**STREETSBORO PLANNING AND ZONING COMMISSION**  
**Regular Meeting**  
**Tuesday April 13, 2021**  
**7:00 pm**

RE: Planter Sign Review- Speedway, 9254 SR 43

RE: Site Plan Amendment for City Park to Locate 2 Sand Volleyball Courts.

**SIGN LOCATION DETAIL**

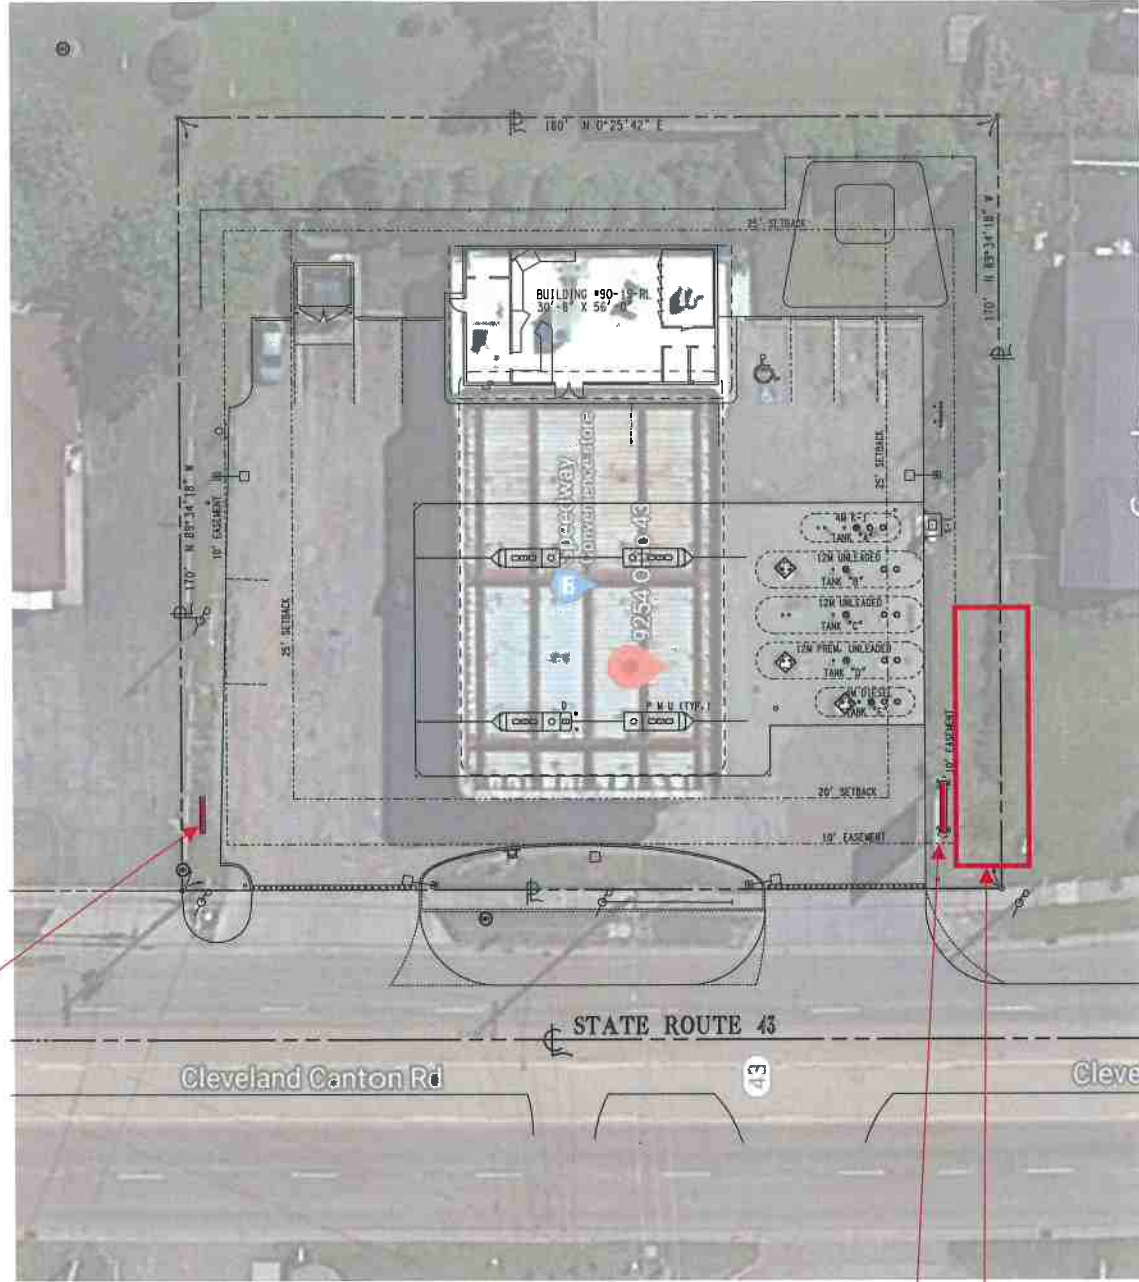
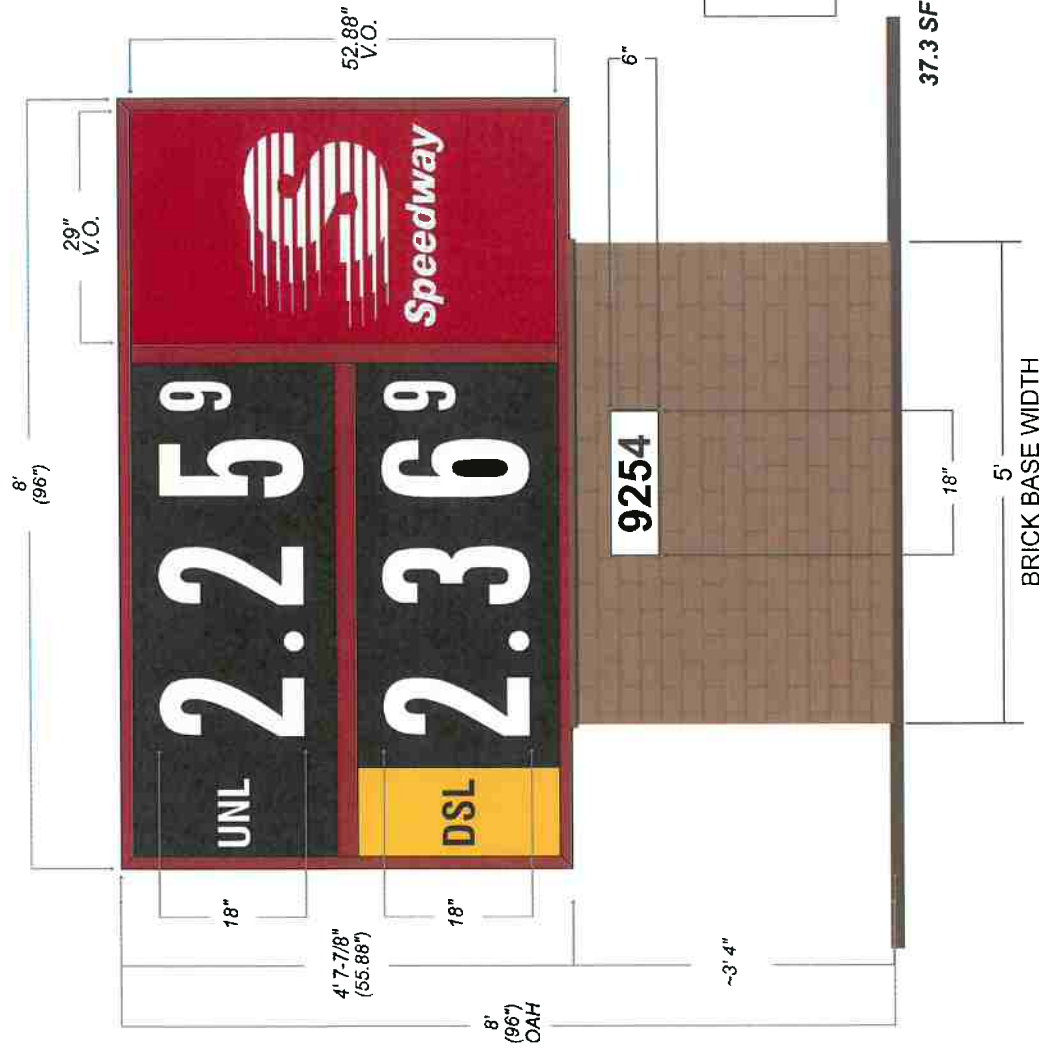
- I. **Planter Sign**
  - a. Sign Area. A 37.2 sq. ft. (8 ft. X 4.65 ft.) planter sign complies with the maximum permitted sign area of 37.2 sq. ft.
  - b. Setback from ROW. The proposed planter sign is set back 12 feet from the State Route 43 right-of-way, which exceeds the minimum required setback of 10 feet.

- c. Setback from Side Lot Line. The proposed planter sign is set back 4.0 feet from the northern side property line. The BZBA approved a variance to permit no less than a 1.5 ft. side yard setback. Since the proposed 4 ft. variance exceeds that which was approved by variance, the proposed side lot line of 4 ft. is permissible, as submitted.

- d. Sign Height. The proposed sign height of 8 feet conforms to the maximum permitted sign height of 8.0 ft.
  - e. Landscaping. No landscape plans have been submitted. It should be noted that the application submittal includes an undated letter from Dustin Lance, Region Manager, Speedway LLC that has been included in the Commission's packet. The letter agrees in writing to submit a landscape plan for the proposed sign and acknowledges that final

sign approval will be contingent upon receipt, review and approval of the proposed landscape plan. Plans should be revised to include a Code-compliant landscaping plan. Staff suggests a mix of deciduous and coniferous shrubs. Colorful perennials also provide nice color.

- f. Illumination. The planter sign is proposed to be internally illuminated with LEDs. Plans note that the proposed sign will not have a luminance more than 400 nits, which is below the Code permitted maximum permitted luminance level for internally illuminated signs. With that being said, staff would ask that plans be revised to show a singular nit reading for the proposed planter sign.
- g. General.
  - i. *Specification Plate*. Per §1159.20, all illuminated signs shall include a Sign Specification Plate.
  - ii. *Bollard Details*. Plans show 3 bollards to be installed between the proposed sign and adjacent parking lot. Plans should be revised to show bollard details including color and height;
  - iii. The proposed planter sign conforms to all applicable dimensional and location requirements of the Zoning Ordinance or as permitted by variance.

1. That plans be revised to include a Code-compliant landscaping plan;
2. That plans be revised to provide a singular nit reading for the proposed planter sign; and
3. That plans be revised to show bollard details including color and height.

Legend:

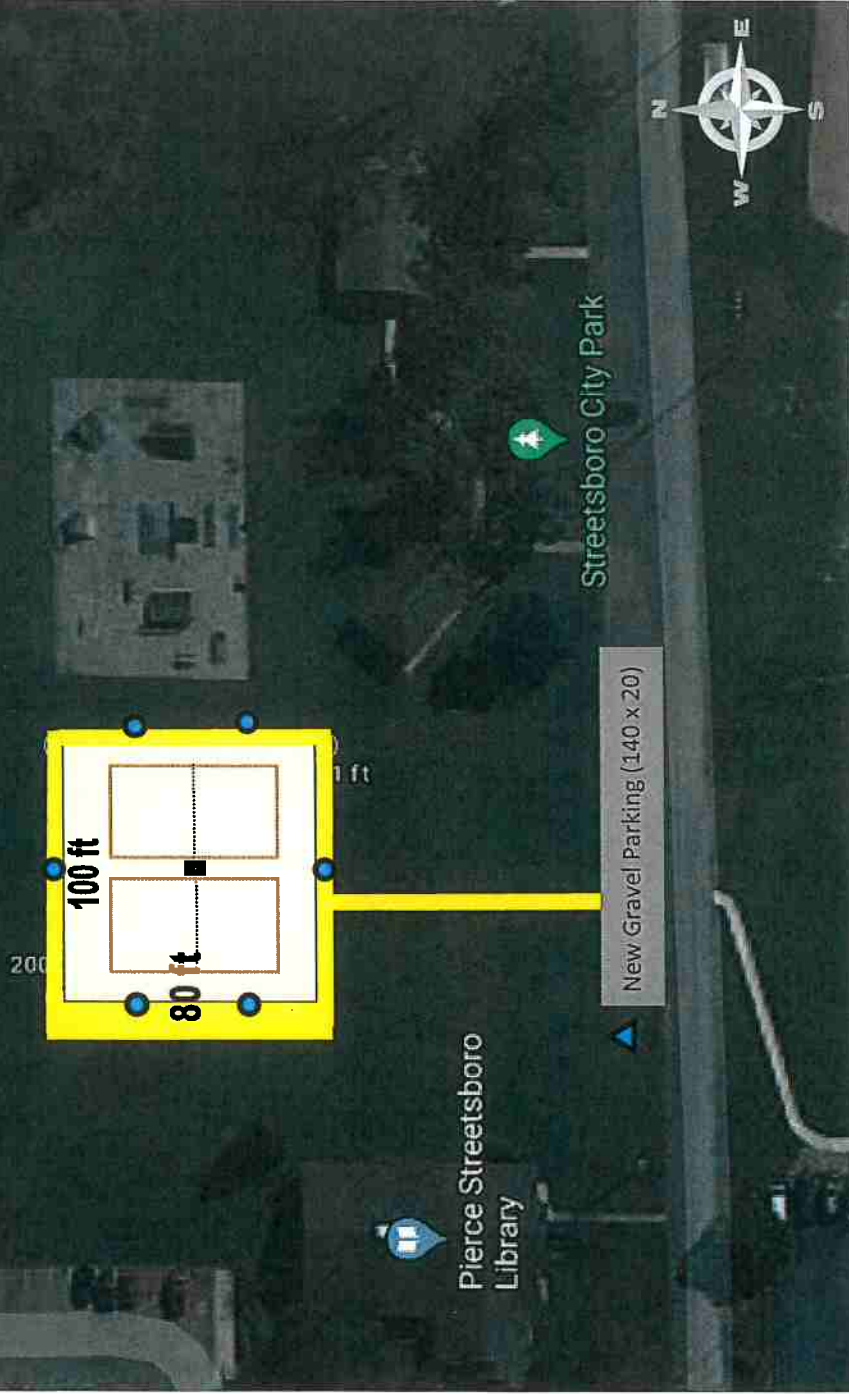
- The proposed court location is not exactly in-line with the Parks and Rec. Comp Plan, however the proposed sand volleyball use constitutes a good holding use that is not as permanent as building a structure. This allows for the flexibility to add future parking and path networks, in conformance with the Plan.

- The proposed sand volleyball courts conform to all applicable Zoning Code requirements. The proposed courts will not create any negative impacts on adjacent properties or existing park uses.
- The proposed outdoor volleyball courts will provide additional recreational opportunities for both City Park visitors, City residents and students at the Streetsboro Elementary School.
- The proposed concrete walkway, linking the volleyball courts to adjacent parking, is proper planning and provides for safe pedestrian access between existing and future land uses.

As noted in the submitted narrative from the Parks and Recreation Director, the courts will be illuminated. Staff has reviewed the submitted photometric plan and can confirm that the proposed lighting will not emit glare onto adjacent properties or rights-of-way.

### WEST ELEVATION

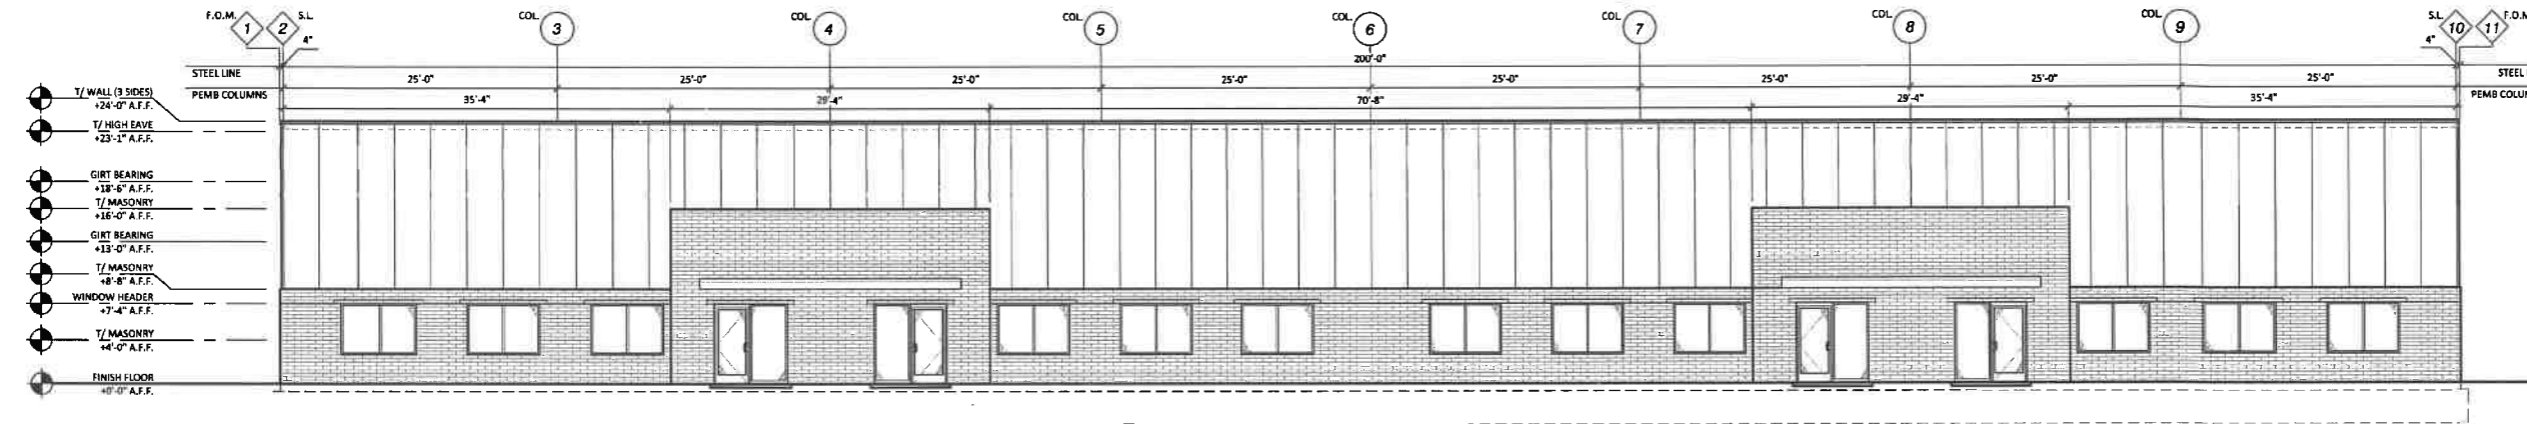
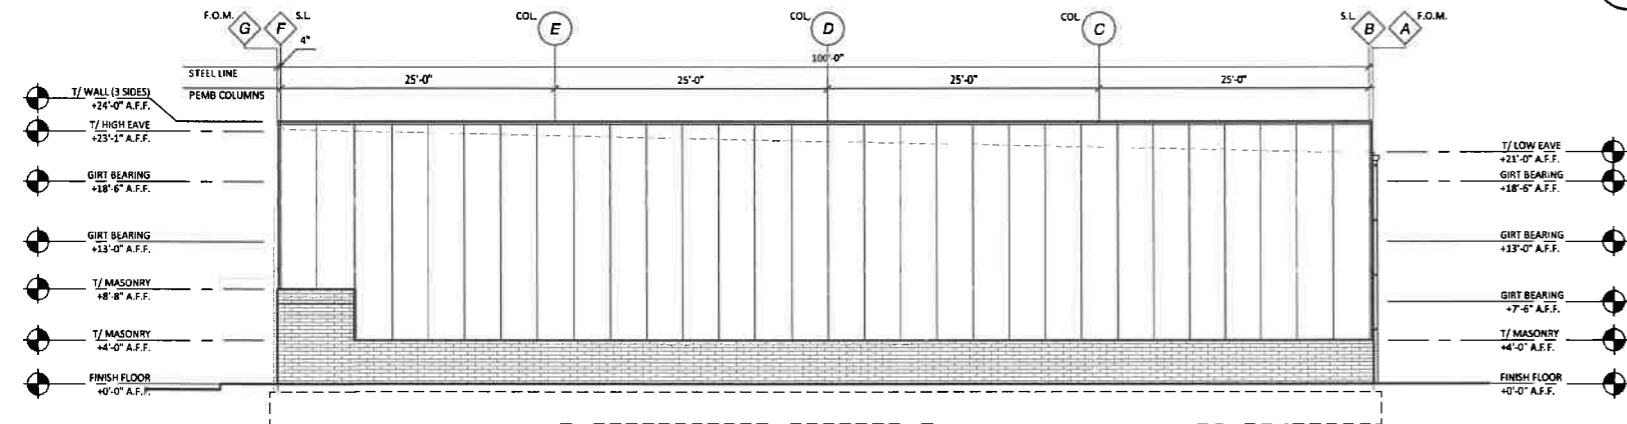
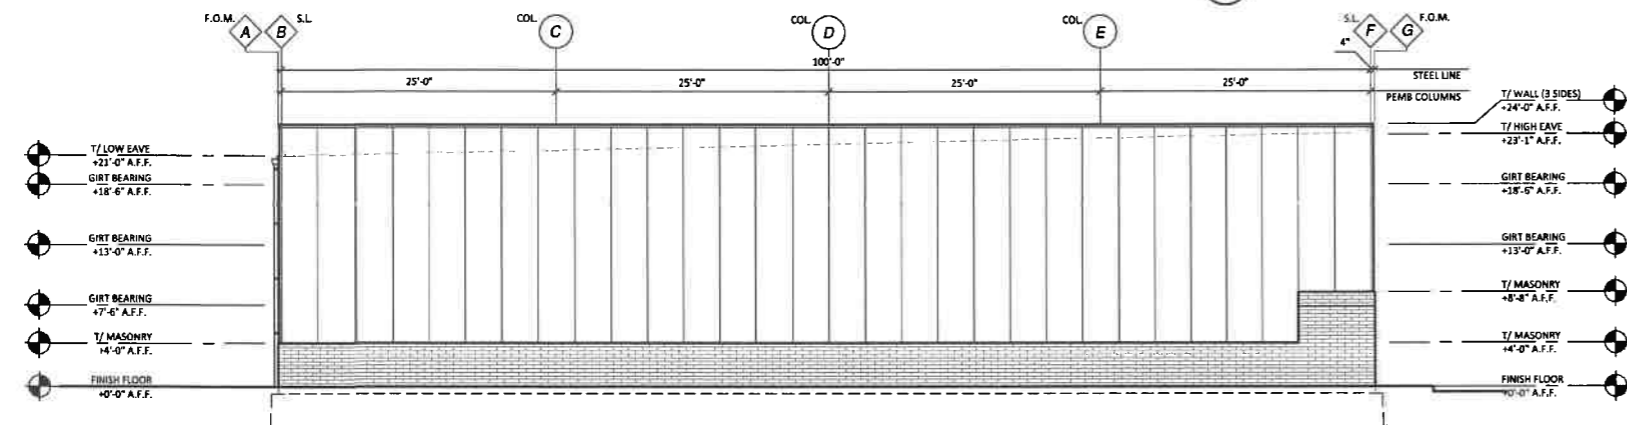
- b. *Downspout Color*. Submitted black and white elevations show downspouts, but color elevations do not show downspouts. Plans should be revised to show color downspouts that either match the adjacent building wall or utilize an accent color that is suitable to the color palette chosen for the principal building.
4. Site Plan (Sheet C102)
  - a. *Dumpster Enclosures*. As also noted in GPDs comment letter, plans should be revised to show proper dumpster enclosures to serve the proposed building and adjoining buildings. There are several existing un-enclosed dumpsters lining the drive aisle adjacent to the subject parcel. Staff recommends that plans be revised to show either separate enclosures for each tenant space or more reasonably a shared central dumpster enclosure area that would serve all 3 buildings (2 existing buildings + the proposed spec building).

- f. *HVAC units.* Plans note a slightly sloped roof and site plans show no ground-mounted HVAC units for the proposed building. The applicant should clarify the location of proposed HVAC units and plans should be revised to show HVAC units and necessary screening. Staff will work with the applicant to adequately obscure HVAC units from view, while also allowing for proper access to the units for maintenance purposes.
5. Landscaping Plan (Sheet LS-1)

3. That color building elevations be revised to specify building materials and colors. The applicant should be prepared to provide the Planning Commission with accurate color swatches and all proposed building materials at the upcoming meeting;
4. That plans be revised to show color downspouts that either match the adjacent building wall or utilize an accent color that is suitable to the color palette chosen for the principal building;
